### STAFF RECOMMENDATION

1805 Sweetbriar Avenue

May 17, 2017

**Application:** Demolition—primary structure; New construction—infill and outbuilding (detached accessory dwelling unit); Setback determination.

Figure 2 (left) shows the two side bays and Figure 3 (right) is the 1957 Sanborn map that shows that the bays are not original to the house.

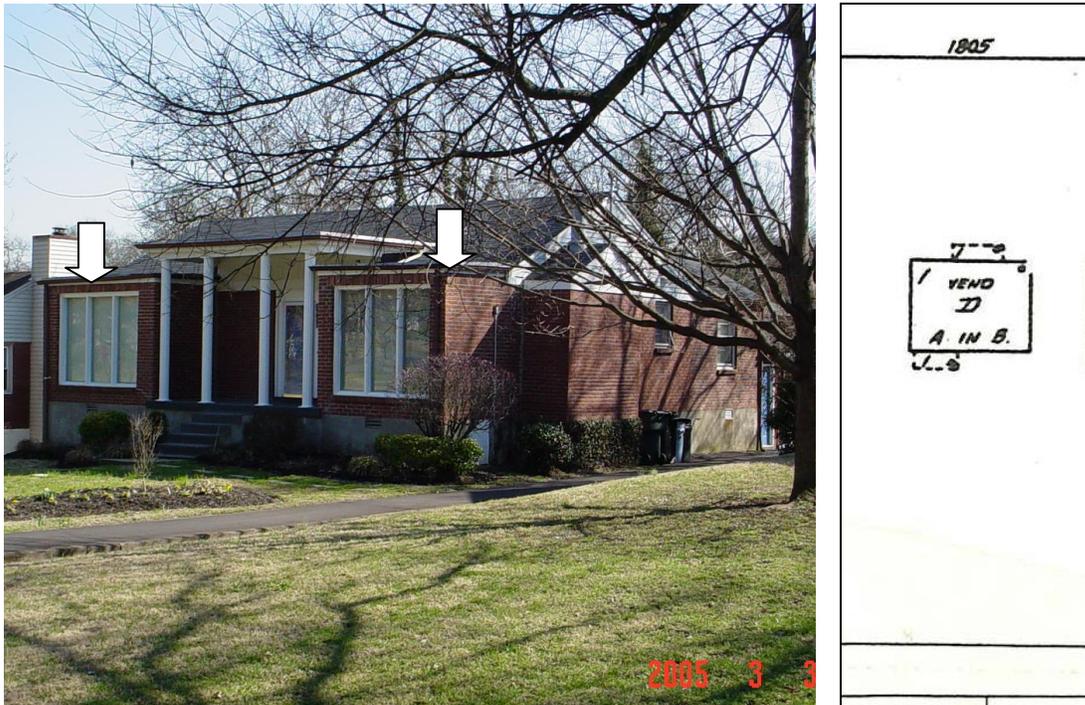
In this case, the date of the house's construction is not the primary factor for determining it to be non-contributing, as a house from that timeframe could be considered contributing in this section of the Belmont-Hillsboro Neighborhood Conservation Zoning Overlay. Rather, it is the alterations done to the house that make the house non-contributing. The two prominent brick front bays are not part of the original house (Figure 2). The bays do not appear in the 1957 Sanborn map of the house. It is not known if the porch's roof form is original, as it is not a typically roof form and style for this period of development. In addition, the house has a plain concrete foundation and vinyl materials, which do not contribute to the character of the historic neighborhood.

Because the existing structure is non-contributing, staff finds that its demolition meets Section III.B.2. for appropriate demolition and does not meet Section III.B.1. for inappropriate demolition.
